Addendum No. 1
Four Rivers Sanitation Authority
Maintenance Building Renovation
Capital Project No. 2102

This Addendum Number 1, dated July 17, 2026, for the above-referenced project, supersedes all contrary and conflicting information in the specifications and contract documents, which are hereby supplemented or revised as follows:

Ref. North Sheet No. A501

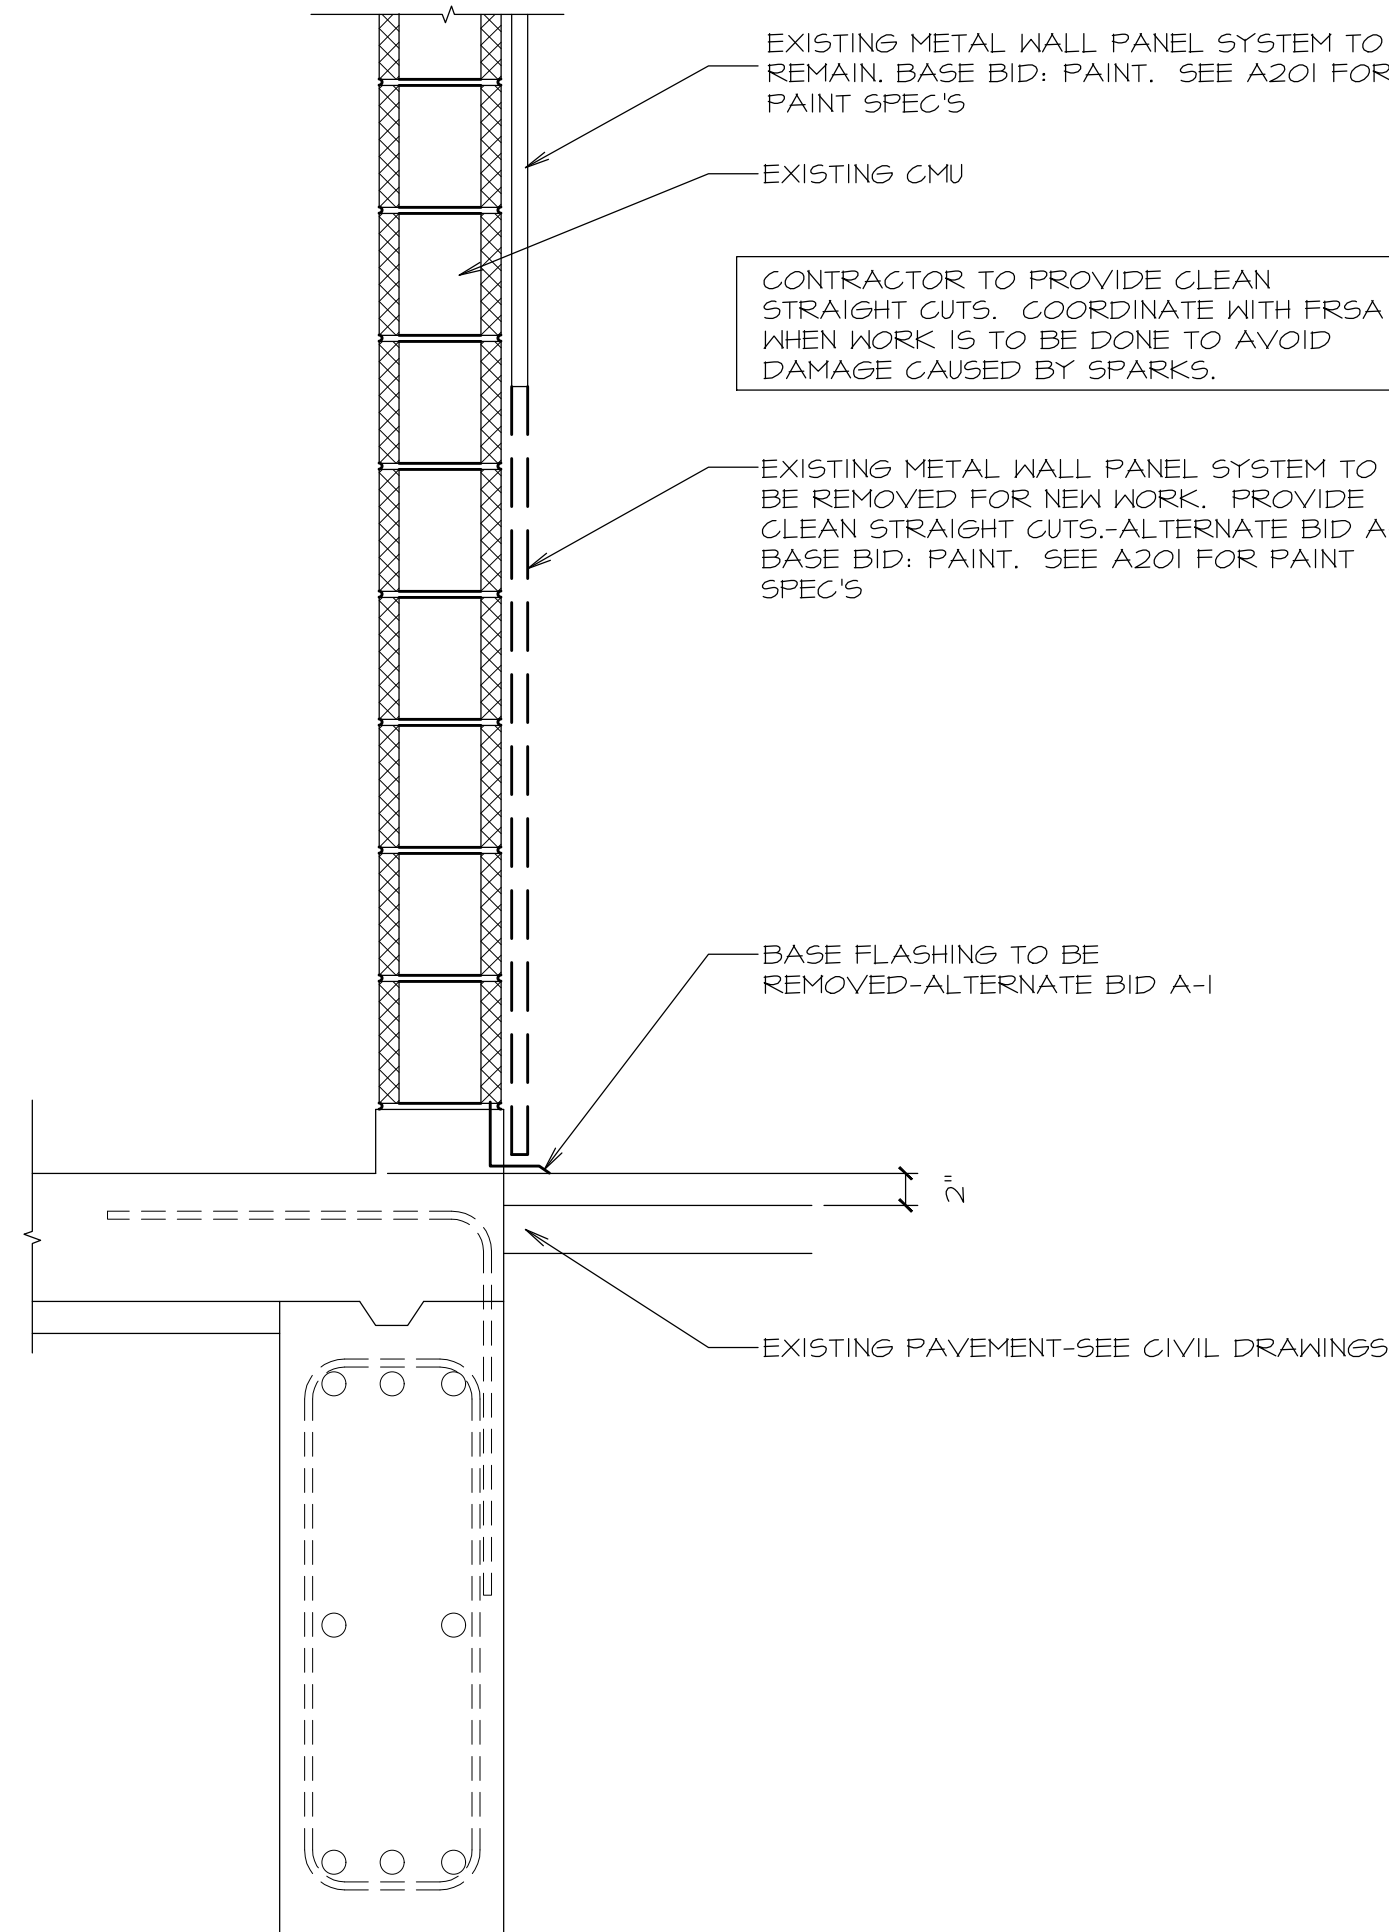
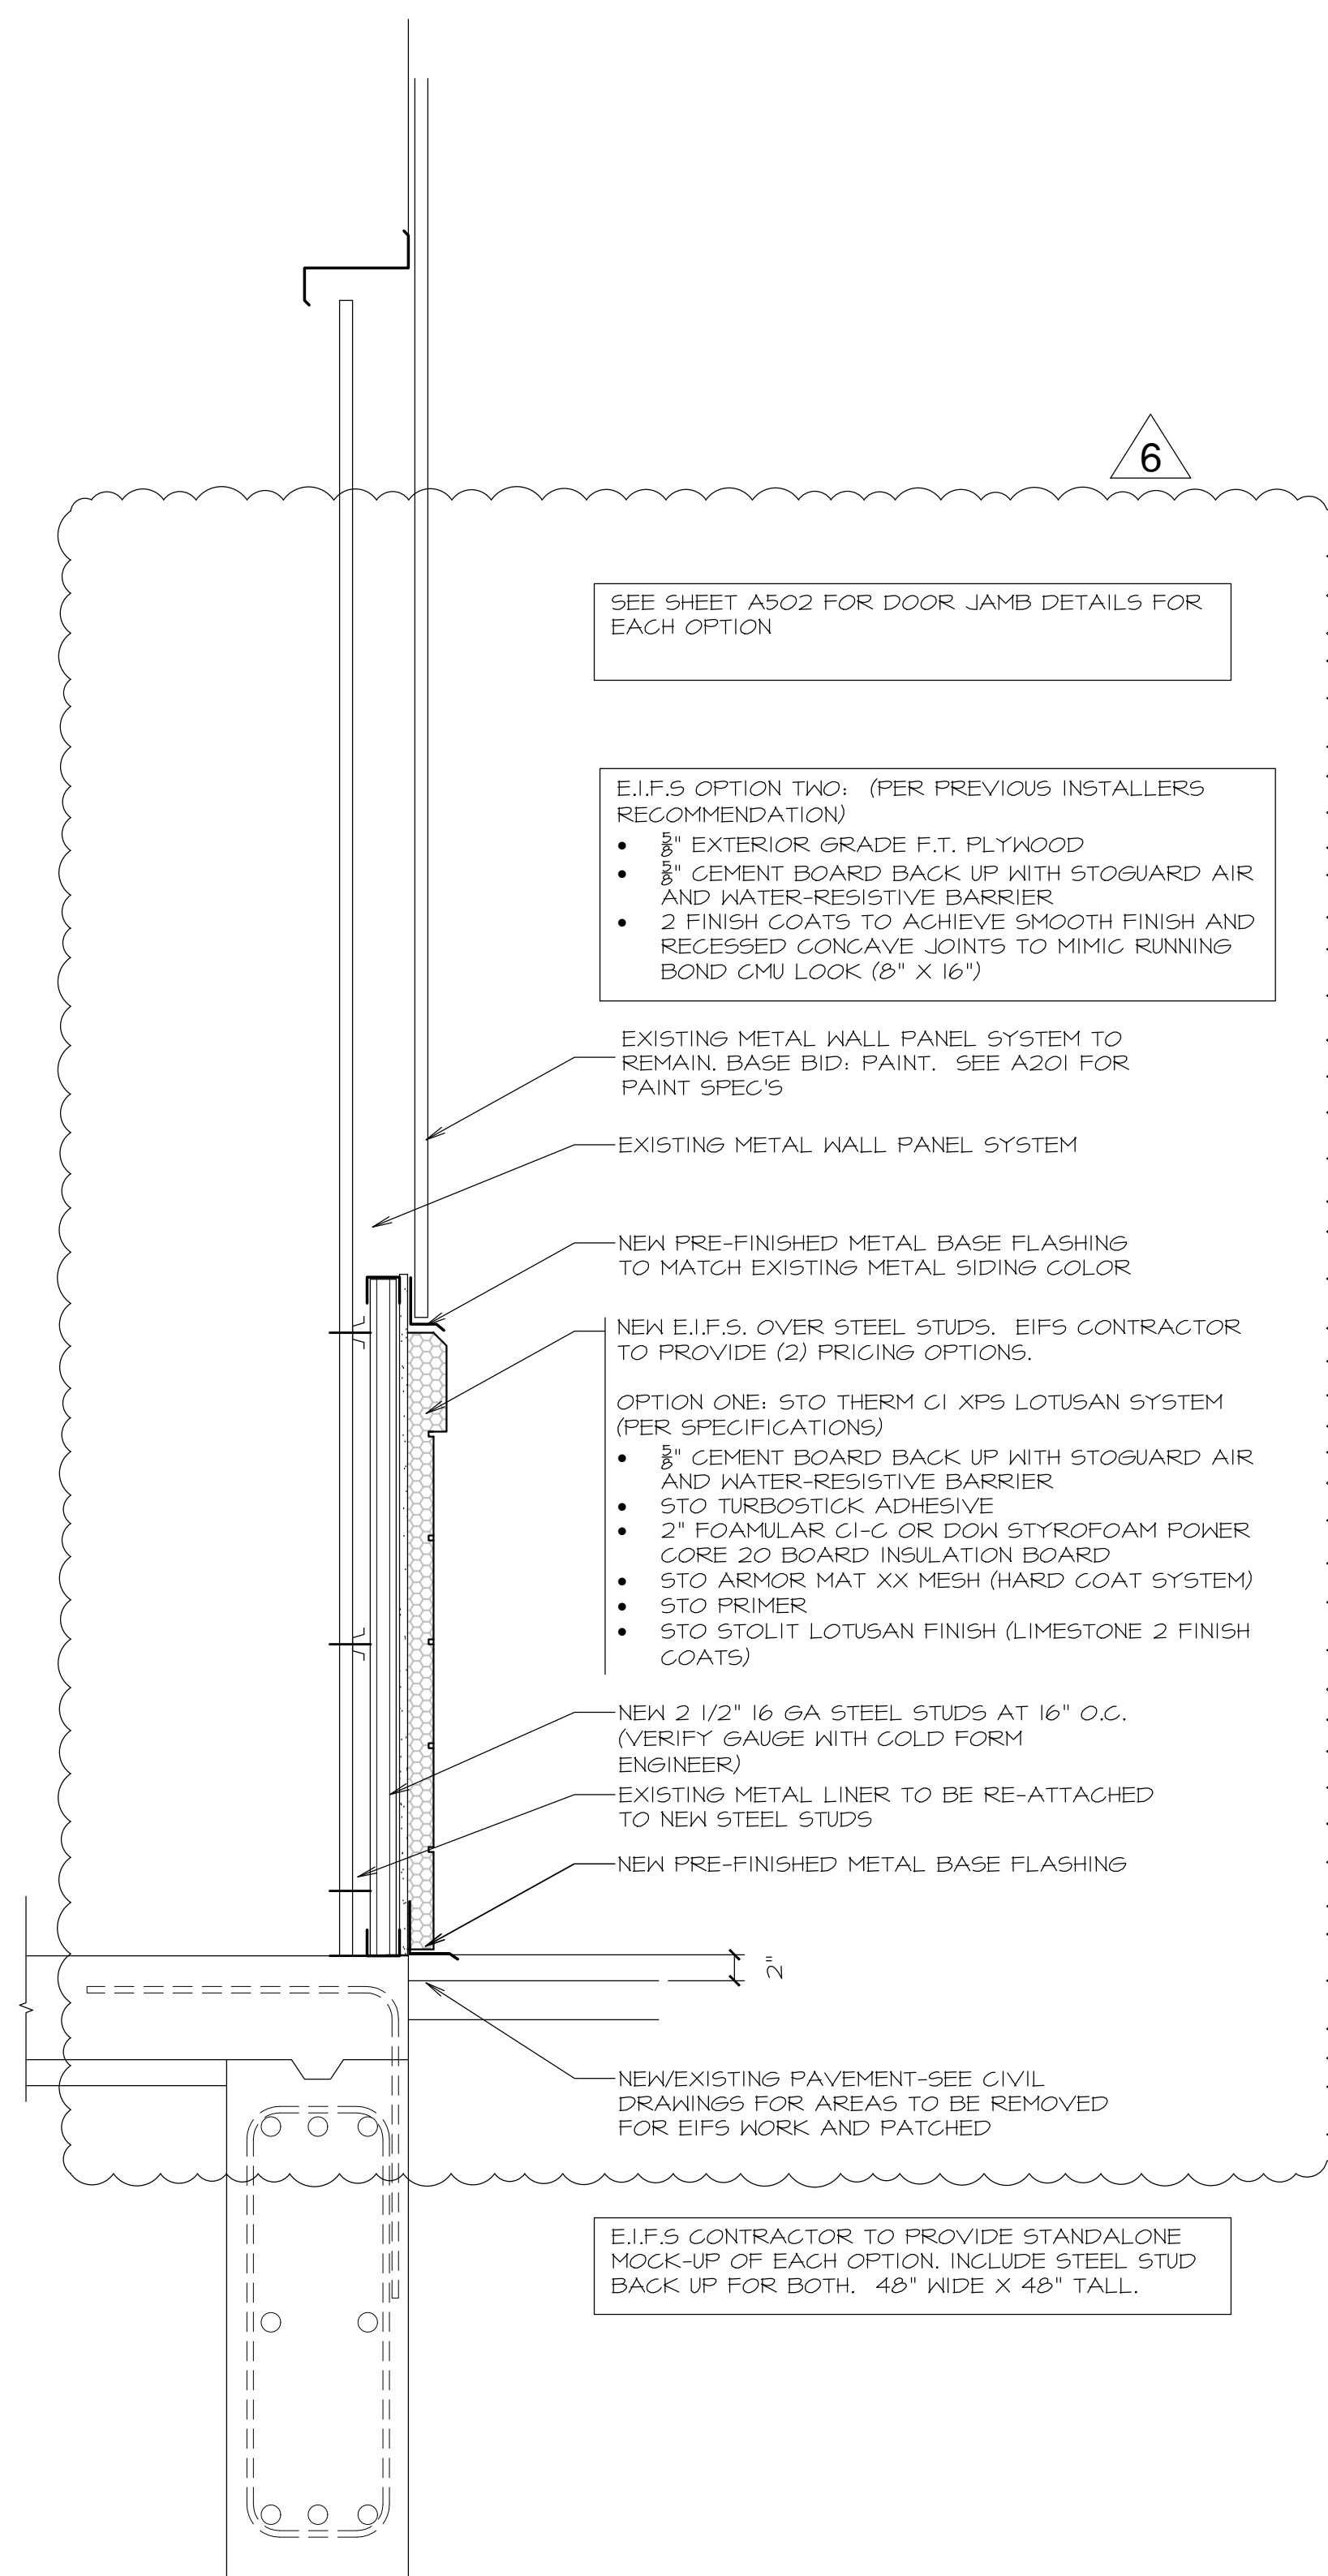
Plan Sheet A501 Details: DELETE Sheet A501 in its entirety and REPLACE with the attached revised sheet which clarifies Alternates and EIFS Options One and Two and corrects steel stud sizes.

Alternate A-1:
Work includes: All work associated with furnishing and installing Exterior Insulation and Finish System (EIFS) belt-course, including removal of existing metal siding and base flashing. See Sheet D201 and this sheet.

Alternate A-1a: Furnish and install EIFS Option One as described in the drawings. See Sheets A501 and A502.

Alternate A-1b: Furnish and install EIFS Option Two as described in the drawings. See Sheets A501 and A502.
